# Access Compliance Report

## Public Rights-of-Way

### (Curb Ramps)

Intersection ID: 32319	Main Street: ARDREY_KELL_RD	Cross Street: BRIDGEVIEW_LN	Location: NE
ADA ID: F8FCB119A265	Ramp Type: Perp	Initial Pass/Fail: Fail	Overall Compliance: No
			Severity Score: 58.75

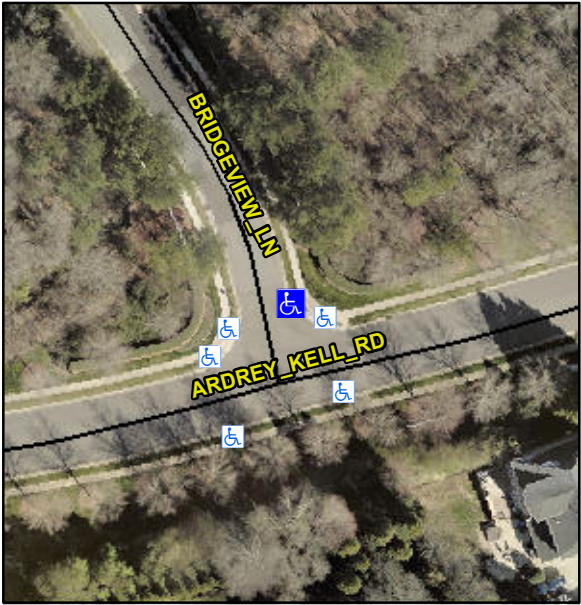
Codes/Mitigation Info/Possible Solution			Field Measurements/Component Compliance			
	Possible Solutions:		<b>Compliance</b>	<b>Description</b>	<b>Data</b>	<b>Compliance</b>
	<b>Remove &amp; Replace Entire Ramp.</b>		<b>No</b>	Ramp Length (in)	<b>49.0</b>	<b>No</b>
			<b>No</b>	Ramp Width (in)	<b>37.5</b>	<b>No</b>
			<b>N/A</b>	Flare Type LT	<b>N/A</b>	<b>N/A</b>
			<b>N/A</b>	Flare Slope LT (%)	<b>N/A</b>	<b>N/A</b>
			<b>N/A</b>	Flare Traversable LT?	<b>N/A</b>	<b>N/A</b>
			<b>N/A</b>	Landing Length (in)	<b>N/A</b>	<b>N/A</b>
			<b>N/A</b>	Landing Width (in)	<b>N/A</b>	<b>N/A</b>
			<b>N/A</b>	Landing Slope (%)	<b>N/A</b>	<b>N/A</b>
			<b>N/A</b>	Landing X Slope (%)	<b>N/A</b>	<b>N/A</b>
<p>Surveyor Notes:</p> <p><b>N/A</b></p> <p>PROW/ADA:</p> <p><b>Not Found, R304.5.1, R304.2.2, R304.5.3</b></p>			<b>N/A</b>	Flare Type RT	<b>N/A</b>	<b>N/A</b>
			<b>N/A</b>	Flare Slope RT (%)	<b>N/A</b>	<b>N/A</b>

<b>N/A</b>	Flare Traversable RT?	<b>N/A</b>	<b>N/A</b>
			<b>N/A</b>	DWS Provided?	<b>N/A</b>	<b>N/A</b>
			<b>N/A</b>	DWS Contrast?	<b>N/A</b>	<b>N/A</b>
			<b>N/A</b>	DWS Length (in)	<b>N/A</b>	<b>N/A</b>
			<b>N/A</b>	DWS Full Width?	<b>N/A</b>	<b>N/A</b>
			<b>N/A</b>	DWS Offset (in)	<b>N/A</b>	<b>N/A</b>
			<b>N/A</b>	Gutter Ponding?	<b>N/A</b>	<b>N/A</b>
			<b>N/A</b>	Gutter Lip Ht (in)	<b>N/A</b>	<b>N/A</b>
<p>Total Cost:</p> <p><b>\$ 1850.00</b></p>			<b>No</b>	Painted X Walk1?	<b>N/A</b>	<b>N/A</b>
			<b>To W</b>	X Walk 1 Direction	<b>N/A</b>	<b>N/A</b>
			<b>N/A</b>	X Walk 1 Width (in)	<b>N/A</b>	<b>N/A</b>
			<b>0.3</b>	X Walk 1 Slope (%)	<b>N/A</b>	<b>N/A</b>
			<b>5.9</b>	X Walk 1 X Slope (%)	<b>N/A</b>	<b>N/A</b>
			<b>N/A</b>	Ramp inside XWalk1?	<b>N/A</b>	<b>N/A</b>
			<b>N/A</b>	Road Slope (%)	<b>N/A</b>	<b>N/A</b>
			<b>N/A</b>	Road X Slope (%)	<b>N/A</b>	<b>N/A</b>
			<b>N/A</b>	Any Obstructions?	<b>N/A</b>	<b>N/A</b>

Obstruction Type	<b>N/A</b>	<b>N/A</b>
			<b>N/A</b>	Storm Grate/Utility Hazard?	<b>N/A</b>	<b>N/A</b>
			<b>N/A</b>	Storm Grate/Utility Type	<b>N/A</b>	<b>N/A</b>
			<b>Yes</b>	Surface Condition? (G/P)	<b>Good</b>	<b>Good</b>
